# Comment Resolution for the MR-O-QPSK PHY

Title: Comment Resolution for the MR-O-QPSK PHY

Re: Task Group 15.4g LB51 comment resolution

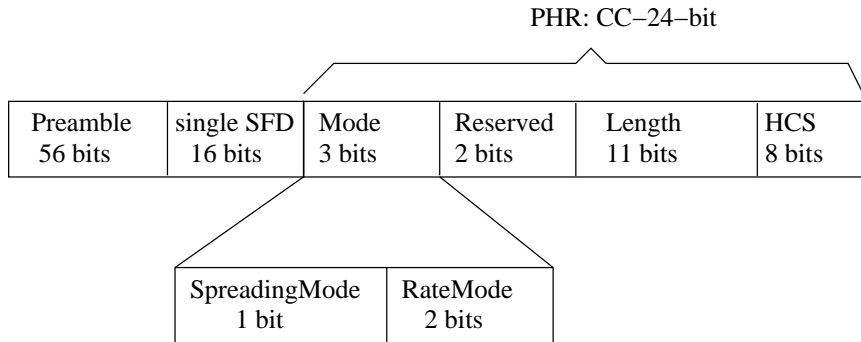
▶ Comment:

- ▶ 2 bits for parity check is questionable.

▶ Resolution:

- ▶ Replace the 2-bit parity bit field by an 8-bit HCS field applying a CRC-8 with generator polynomial  $X^8 + X^2 + X + 1$
- ▶ Performance of a CRC-8 is sufficiently good, see doc # 15-10-0435-02-004g.
